RE: Data Gap Work Plan Addendum

Foothill Mini Mart
6600 Foothill Boulevard, Oakland, California
Fuel Leak Case No. RO0000175
GeoTracker Global ID: T0600102286

Data Gap Work Plan Addendum

**Proposed Location of Additional
Monitoring Wells and Soil Borings**
6600 Foothill Blvd, Oakland, CA 94605

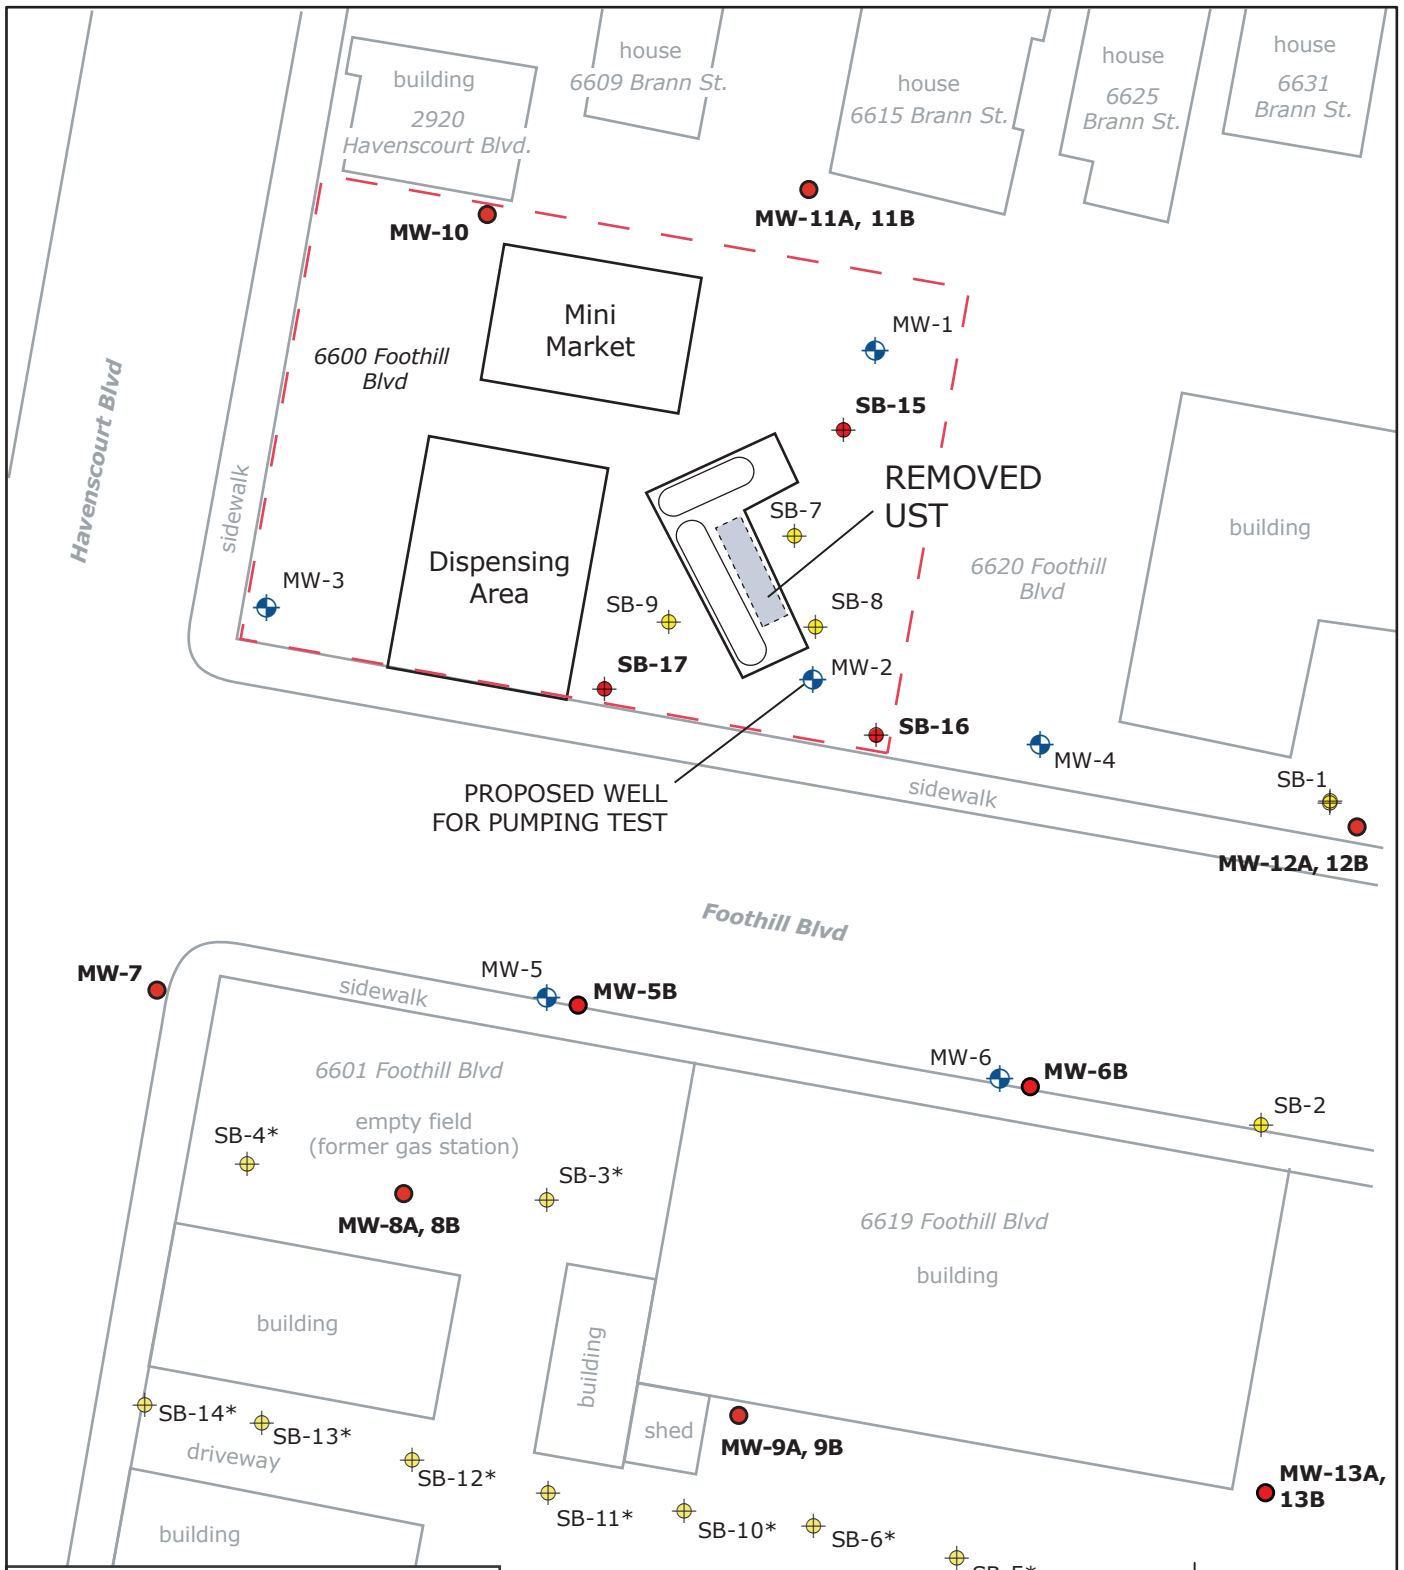
- 1.1 Need an additional monitoring point (shallow and deep) near the southeast corner of the building located at 6619 Foothill Boulevard
- 1.2 Need deeper monitoring wells adjacent to existing shallow monitoring wells MW-5 and MW-6
- 1.3 Need to clarify the method used to identify the second water bearing unit and the method to install well pairs

Sufficient data has been collected to demonstrate the approximate vertical and lateral extent of the source areas. Three soil borings, SB-15, SB-16, and SB-17, are proposed to confirm and further delineate the delineated source area. The proposed soil boring locations are shown in Figure 3. The updated scope of work and investigation methods is described in Sections 3 and 4.

Location of Subsurface Utilities That May Influence Contaminant Migration
 6600 Foothill Blvd, Oakland, CA 94605

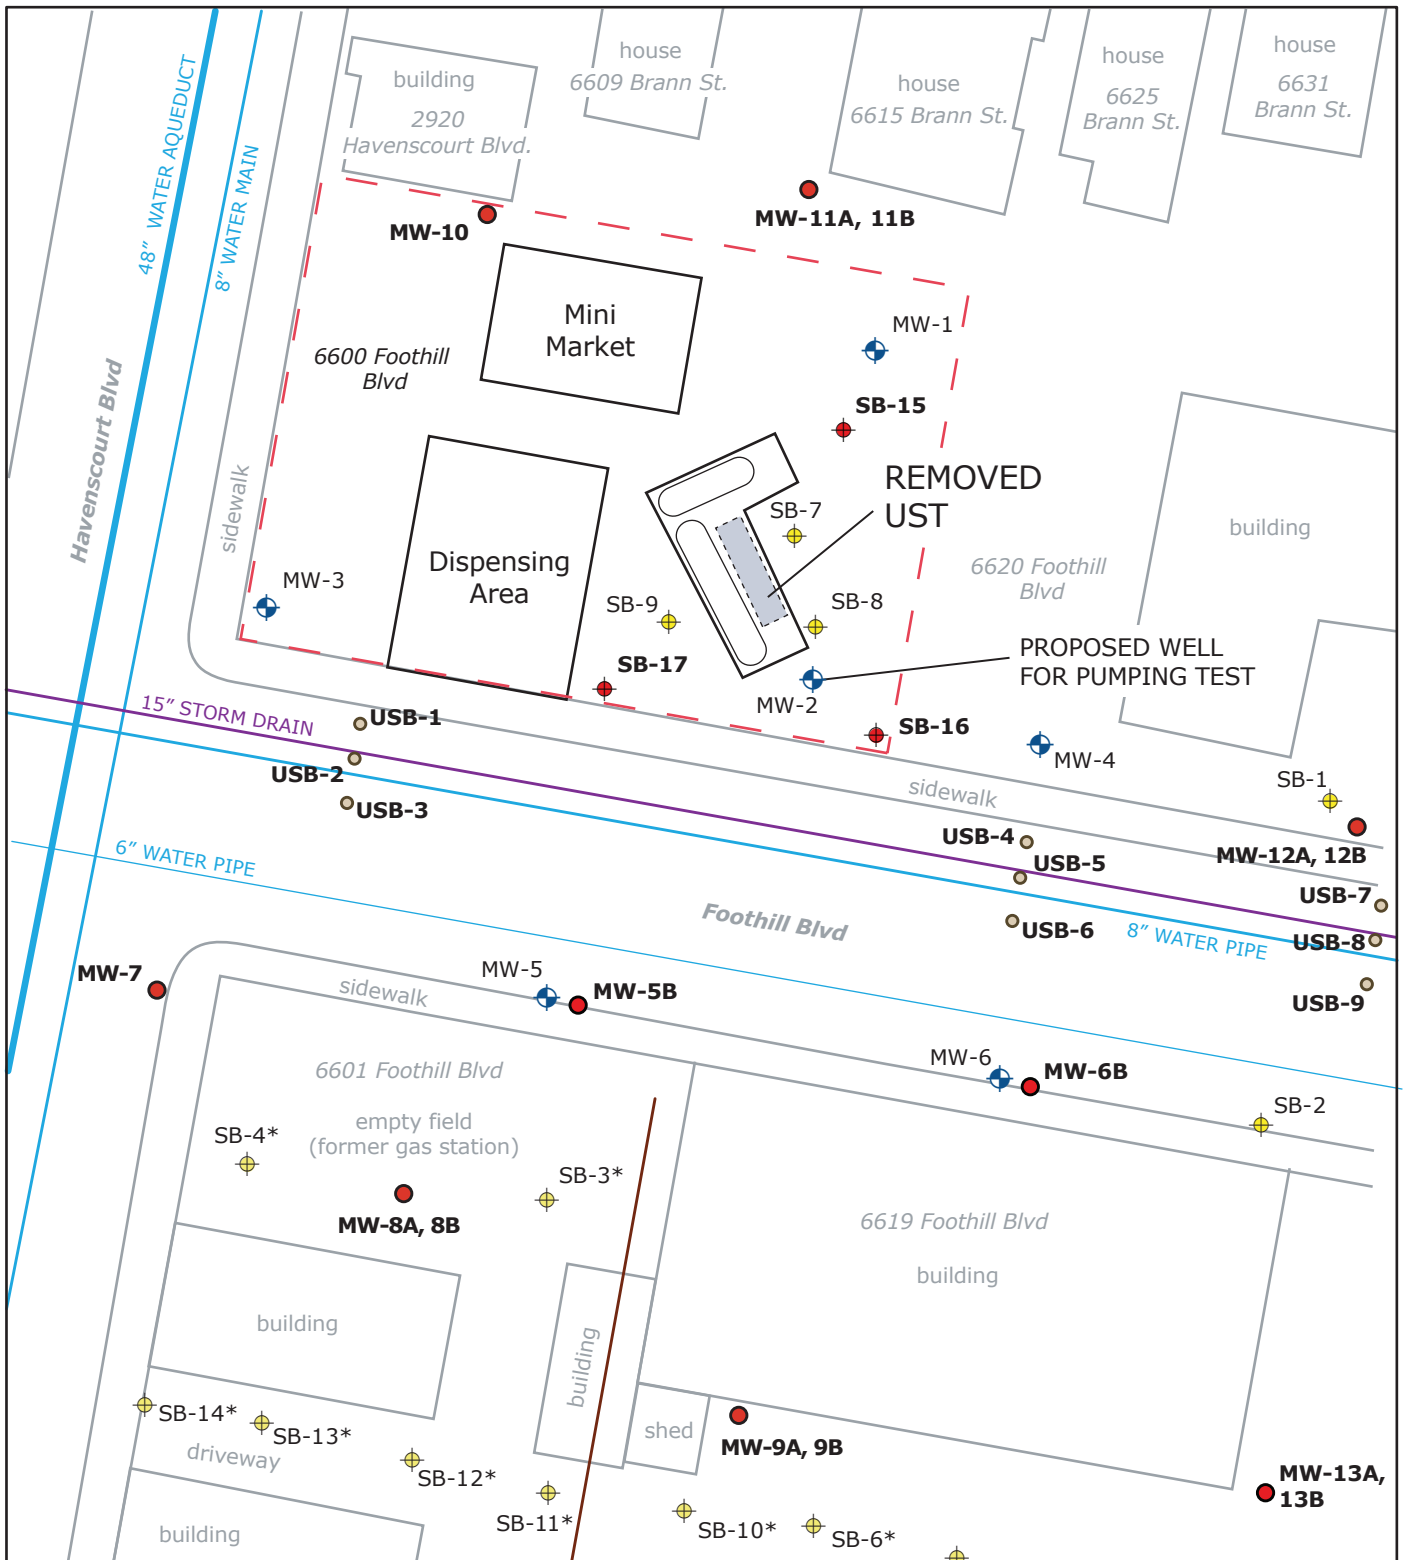
- 3.1 Need to ensure the proposed monitoring well locations will address possible migration of contaminants along the utility corridors on Havenscourt and Foothill Boulevards
- 3.2 Need to include a figure illustrating the relation of the above utility corridors with the site and the sampling points

Response to Comments #1, #2, and #3. ERS concurs with ACEH's Technical Comments #1 through #3. The revised scope of work and investigation methods is discussed in Sections 3 and 4. The relation of the utility corridors to the source area and sampling points are discussed in Task 3 of Section 4.
